**Updated: July 11, 2008**

**Product: SHOWGUN automated luminaire**

**Subject: Loose tilt adapter screws**

Tilt Adapter Screw

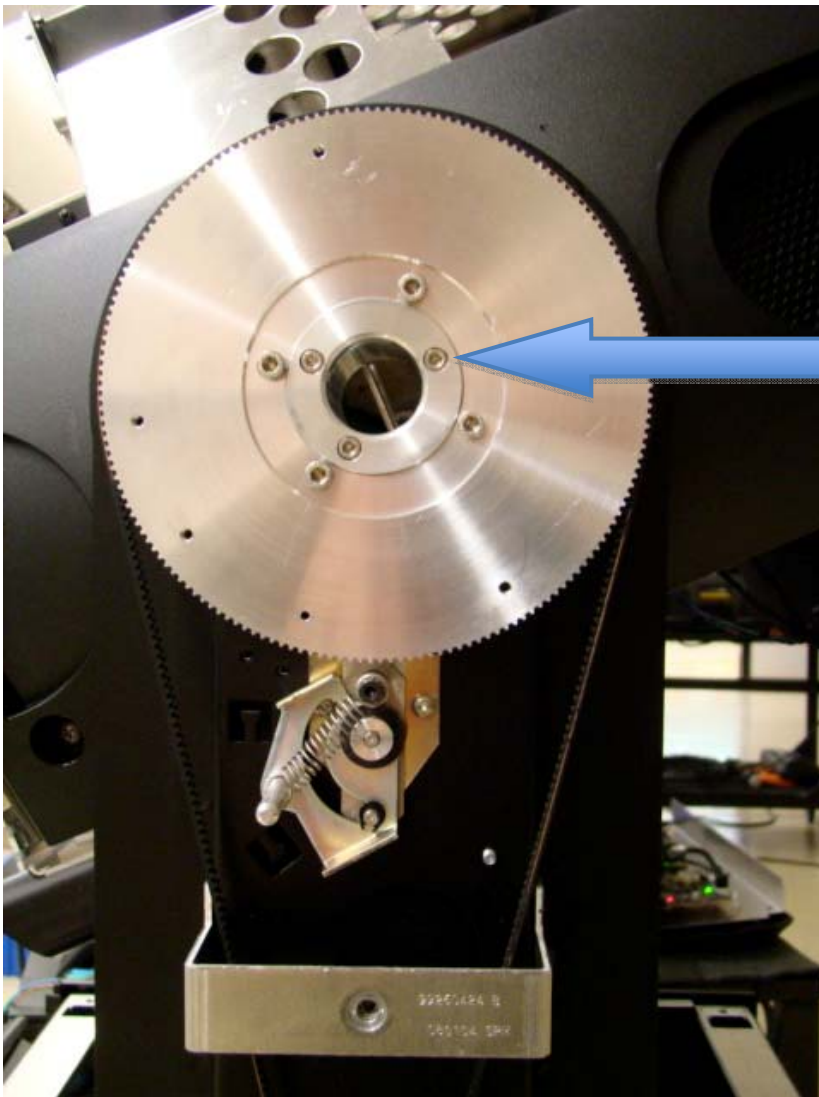
The tilt adapter screws on some SHOWGUN fixtures may work loose. If you find that you have this issue, you may simply tighten the tilt adapter screws to the factory specified setting of 30 inch-pounds. In rare instances the screw could strip out and will need to be replaced with a M4x18 socket cap screw. These screws can be found through a local hardware supplier, or contact High End Systems Product Support at 1-800-890-8989.
